RE: Copper World Project – Aquifer Protection Permit Application – Response to “Follow-up Questions” on September 20, 2023 to Inadequate Response to a Comprehensive Request for Additional Information” – Clarification Requested Via Email on October 11, 2023

This letter transmits responses to the Follow-up Questions received via email from the Arizona Department of Environmental Quality (ADEQ) on October 11, 2023. These questions were in relation to the submittal to ADEQ dated September 20, 2023. This submittal was titled “Copper World Project – Aquifer Protection Permit Application – Response to a Comprehensive Request for Additional Information”, dated June 23, 2023

Illustration 9-1 Heap Leach Pad (Dwg 104-2-007 from September 2022 APP Application, Appendix I.10)

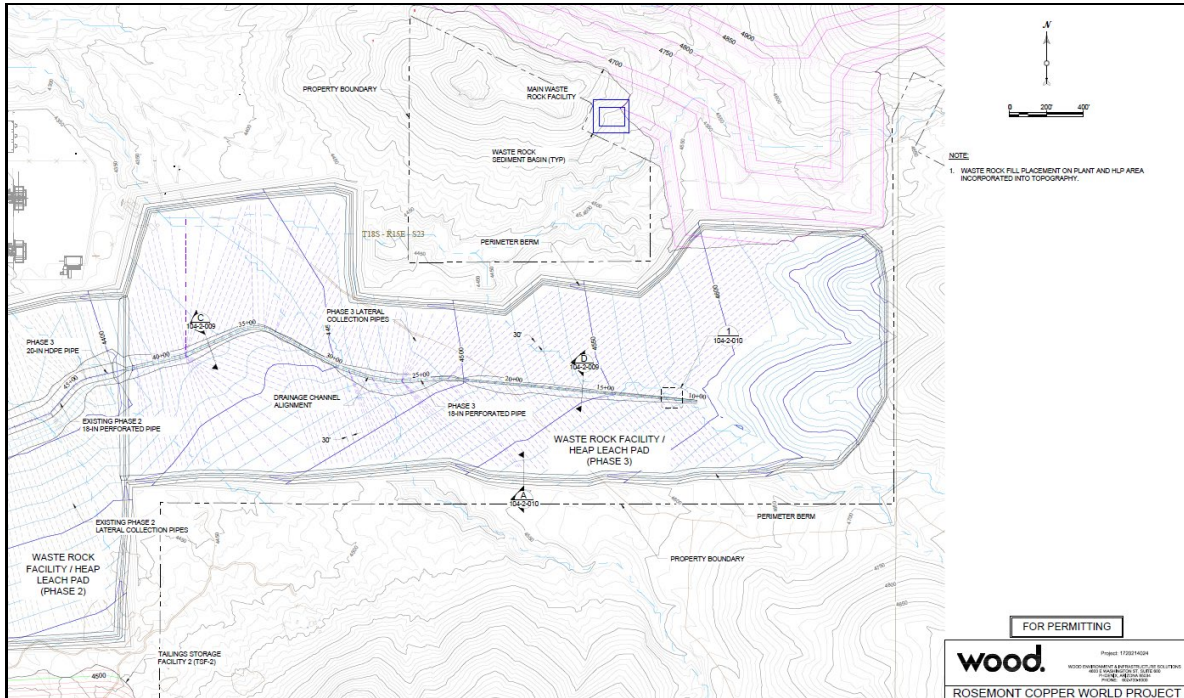
- 9.i. The Leach pad progression provided on the Attachment 8 has some area between north and south of the HLF that is not filled. During the meeting on October 11, 2023, you indicated that this area is where the pipes will be placed. Explain and show cross-sections and/or elevations. (ADEQ clarification email request dated October 11, 2023)

*Response: The gap between the north and south waste rock base of the Heap Leach Facility is due to the grading configuration planned for the Heap Leach Pad (HLP) drainage system. (see **Illustration 9-1** below). The base for the leach pad is graded down to native ground with fill placed to the north and south of this central area. Plan and sections views were provided in Appendix I.8 Heap Leach Pad Pipe Settlement Analysis and Appendix I.10 Rosemont Copper World Technical Report Summary on PFS for Tailings Storage Facilities, Heap Leach Facility, and Waste Rock Facility (Dwg 104-2-007) of the September 2022 APP application. (ADEQ clarification email request dated October 11, 2023)*
